TITLE SCHEMATIC, +12V(4A)
-12V(1A) POWER SUPPLY BD.
(1227-1203)

REV	DATE	APV	DWN	PJK	12/17/93	DWG. NO.	REV
FINISH	---	---	CHK	DWB	12/20/93	1227-3203	1
REL	DWB	12/20/93	C	SCALE	---	SHEET	1 OF 1

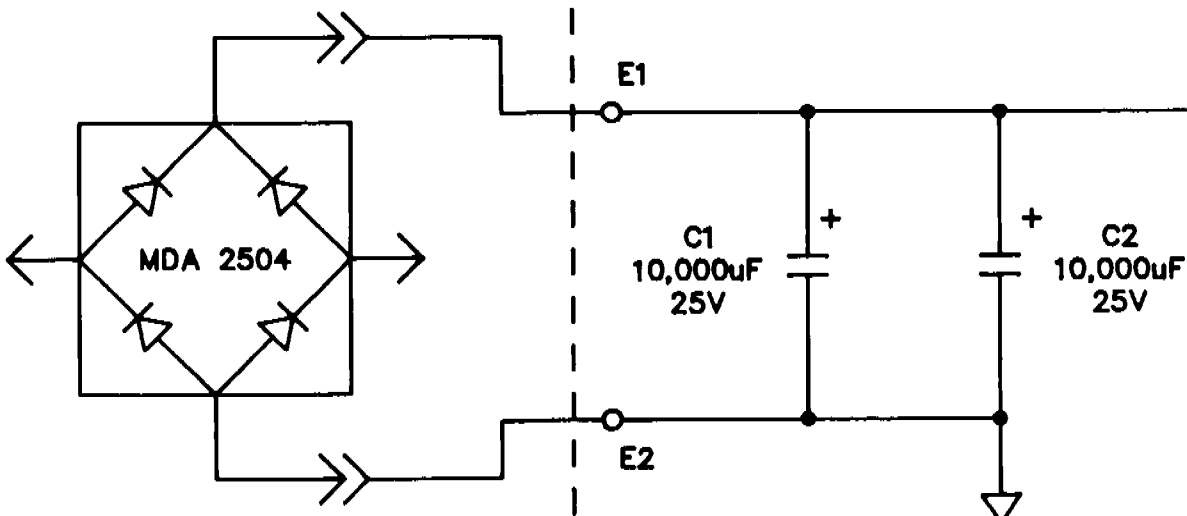
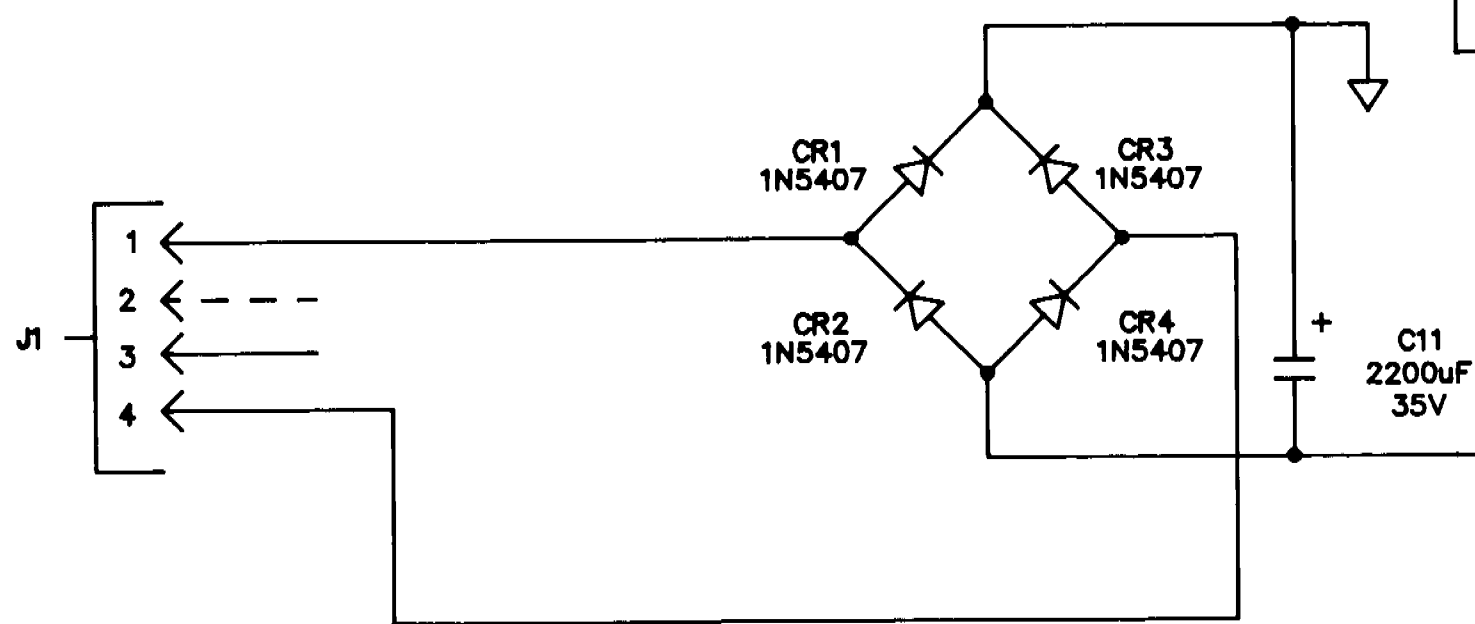
CHANGED C1 AND C2 FROM
35V TO 25V. CHANGED
U1-U4 FROM 7812 TO
MC7812CT AND CHANGED
7912 TO MC7912CT. ADDED
NOTE 1. (RFB)
